Wollongong Local Planning Panel Assessment Report | 15 November 2022

WLPP No.	Item No. 1
DA No.	DA-2022/297
Proposal	Residential - installation to external lift addition
Property	6 Ross Street, Wollongong
Applicant	Vortex Developments Pty Ltd
Responsible Team	Development Assessment and Certification - City Centre & Major Development Team (HK)
Prior WLPP meeting	N/A

ASSESSMENT REPORT AND RECOMMENDATION

Drawing No:
1438-B02
No in set : 3

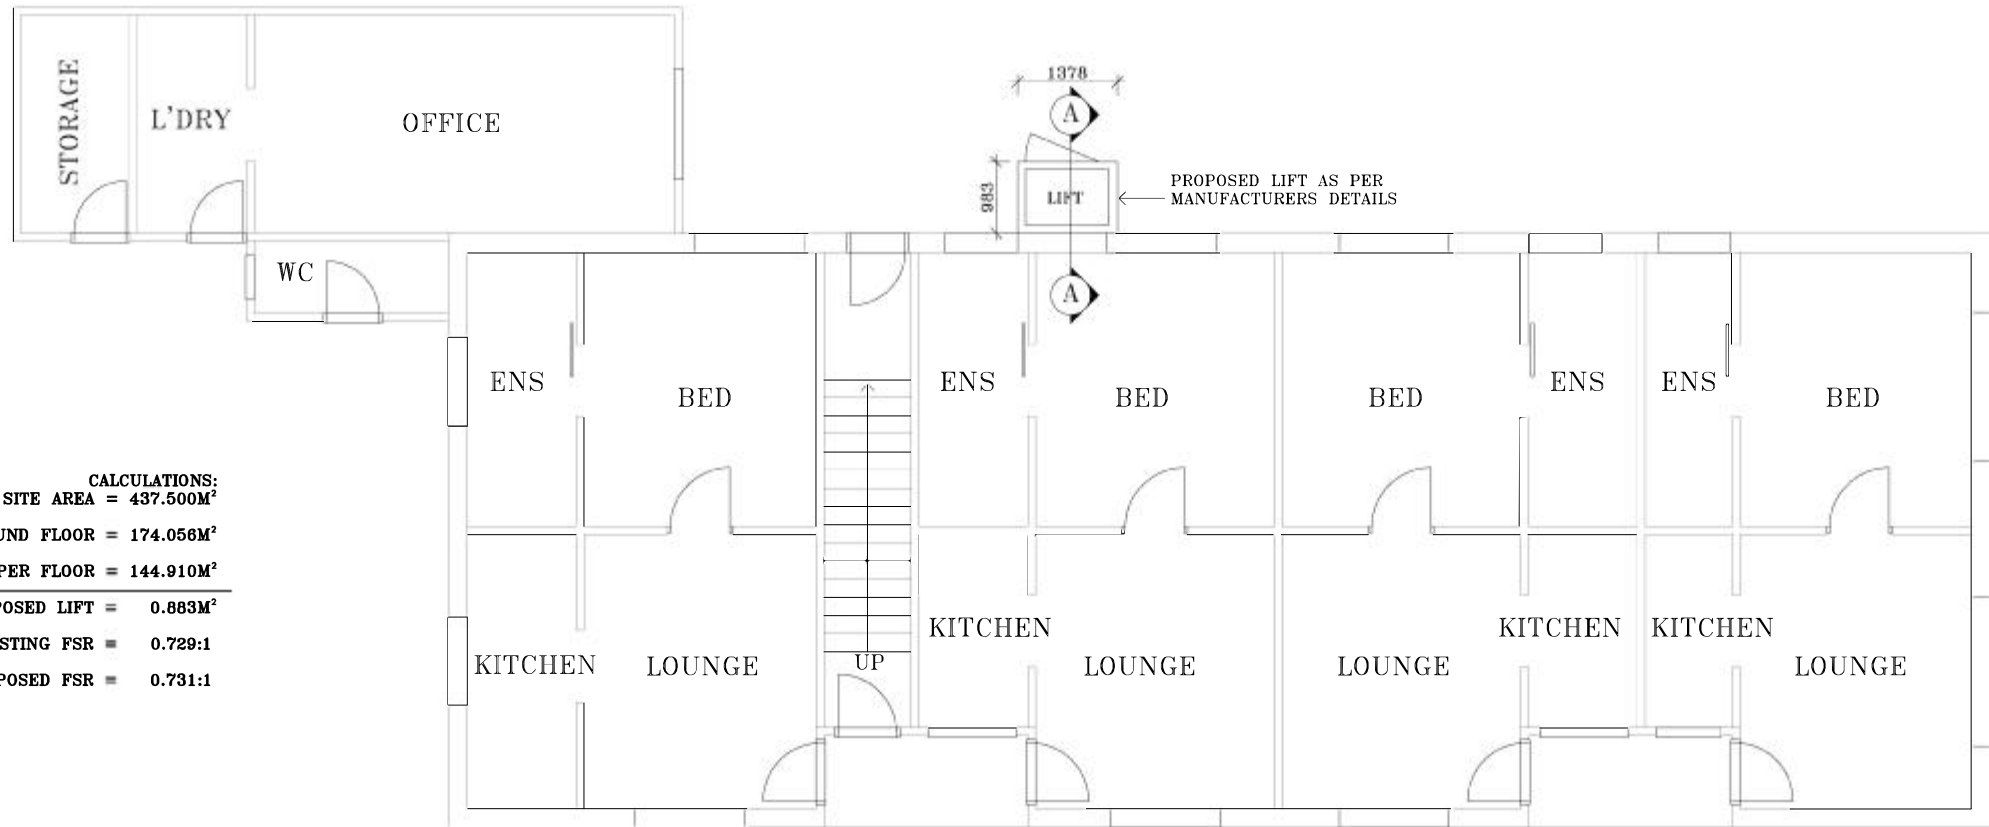
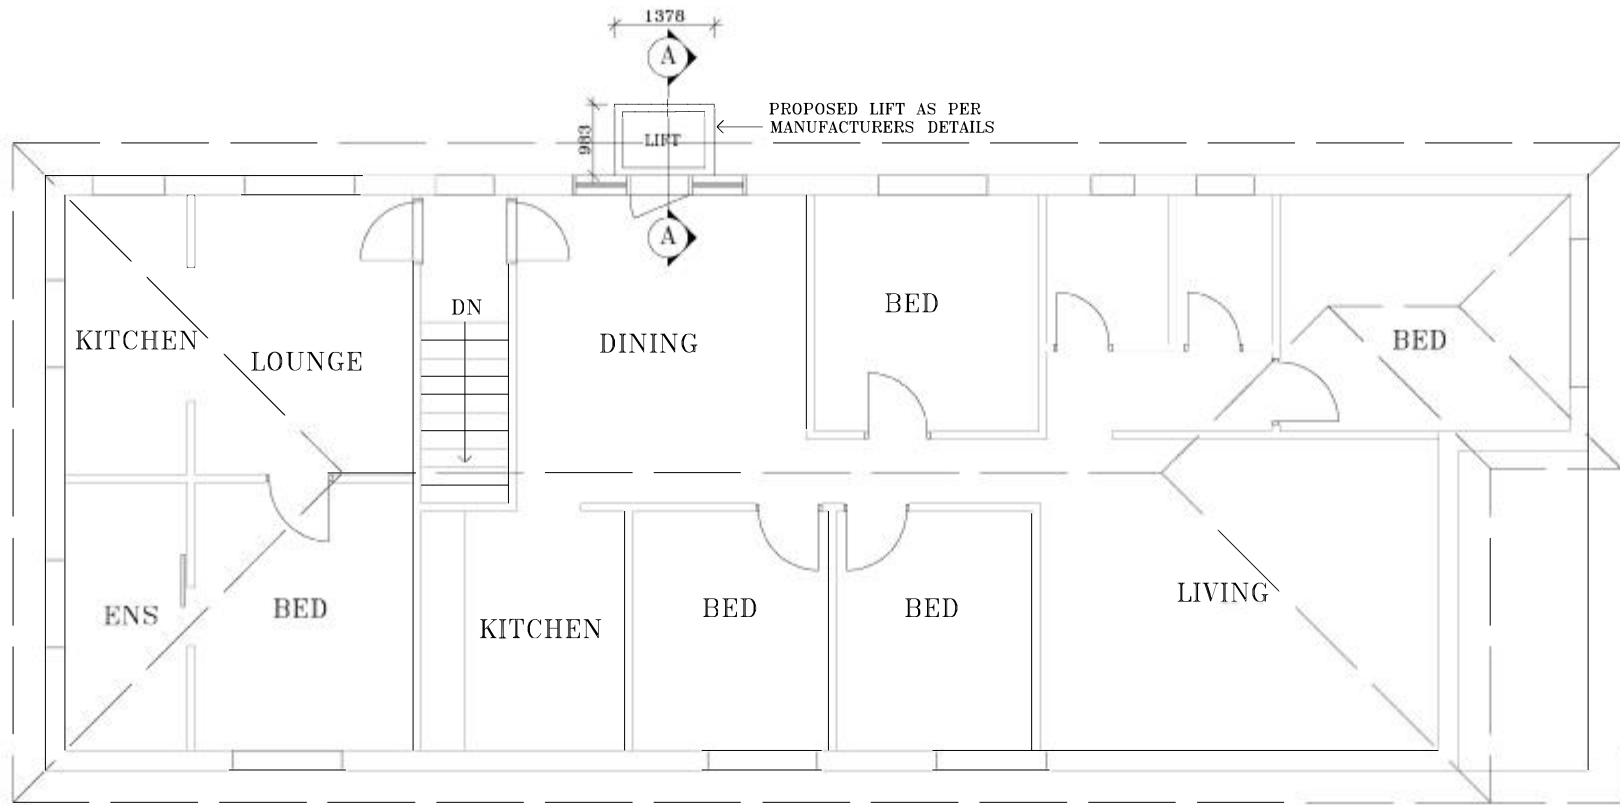
The main issues are a 4.6 request for additional gross floor area and DCP variation to side setbacks and loss of a potential parking space.

a) The control being varied; and	The control being varied is Clause 6.4.2 (1) of chapter B1 of WDCP 2009.
b) The extent of the proposed variation and the unique circumstances as to why the variation is requested; and	<p>Extent of the proposed variation:</p> <p>The elevator is proposed to be 2.27m from the western setback. A deficiency of 1.23m</p> <p>Unique circumstances:</p> <p>None</p>

The current building has 6 dwellings and has two driveways. Currently, the only way each dwelling would get at least one on-site parking spot is if each driveway had three spaces in a stacked parking arrangement. Each spot would be assigned to a separate dwelling. The external elevator is located in the driveway and would remove a 'three deep' stacked parking spot. Two parking spaces are still possible in front of the elevator. A three-space stacked parking arrangement would still be on the eastern driveway.

Drawing No:
1438-A03
No in set :3

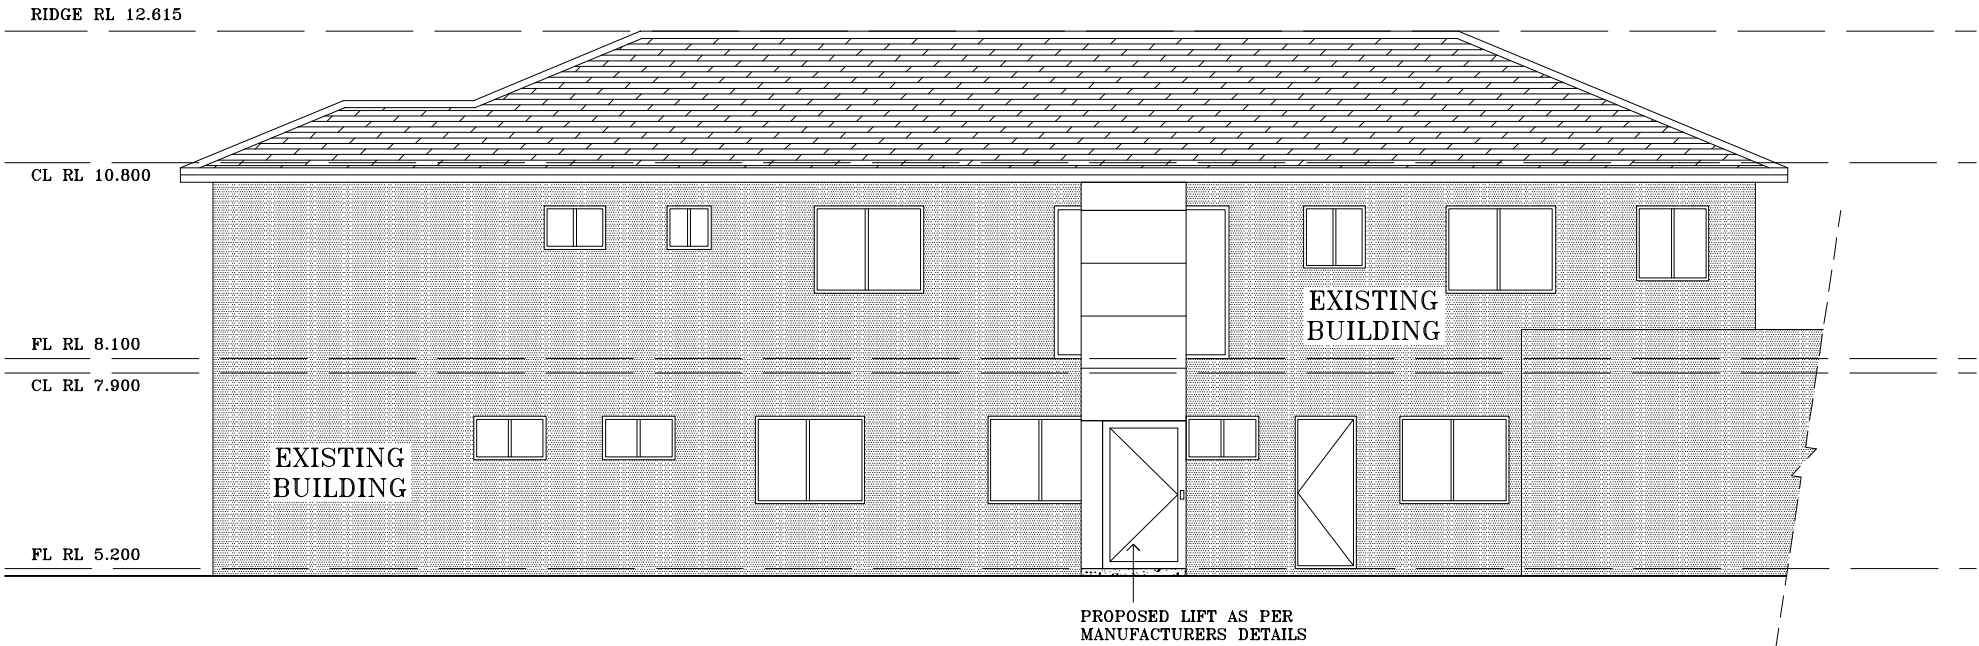
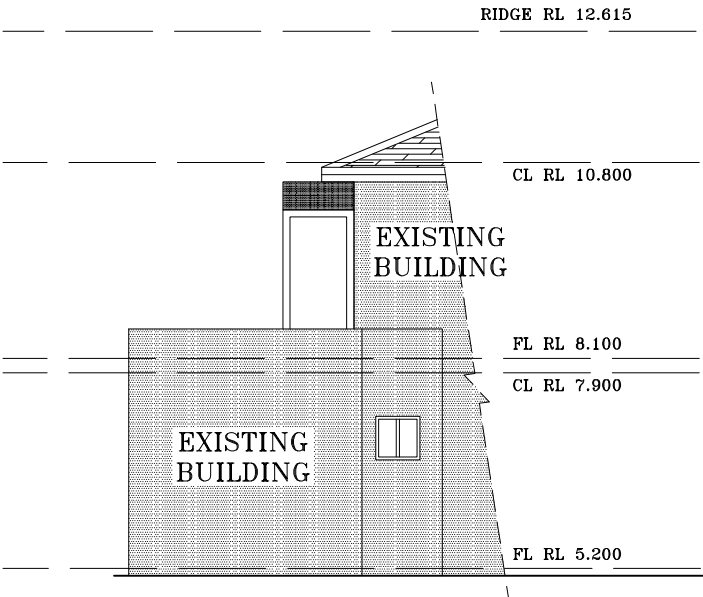
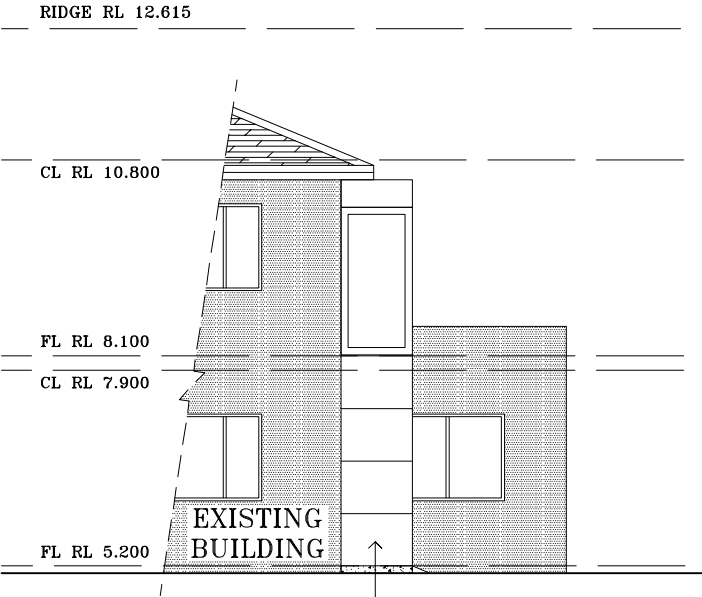
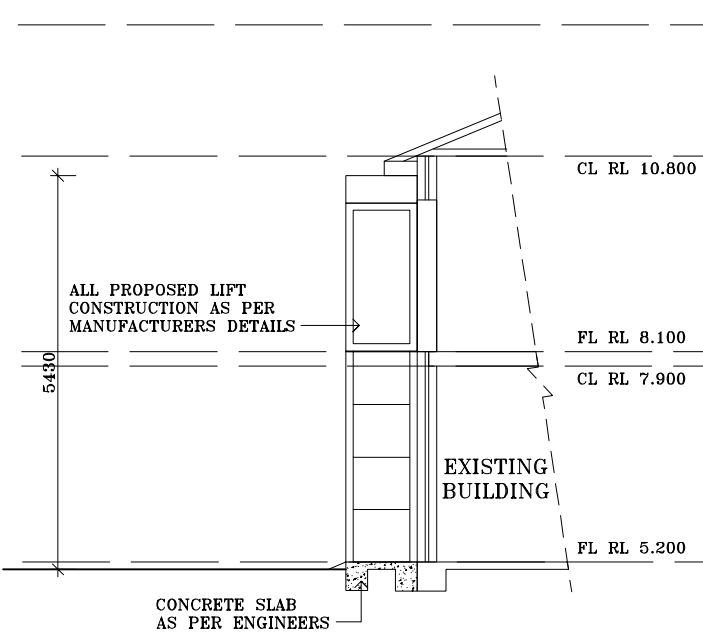
The proposed elevator height of 5.43m does not exceed the maximum of 9m permitted for the site. The top of the elevator will sit below the existing eaves.

- The lift addition has solid, metal clad external walls with the only external glazing being the ground floor lift access door, which faces the north. The lift therefore does not provide any opportunity for overlooking of the neighbouring property to the west.

- The lift addition is only modest in size – being just 1.378m wide and sitting below the level of the eaves of the existing building. Accordingly, the proposal will have a negligible impact on the visual amenity of the western neighbour.
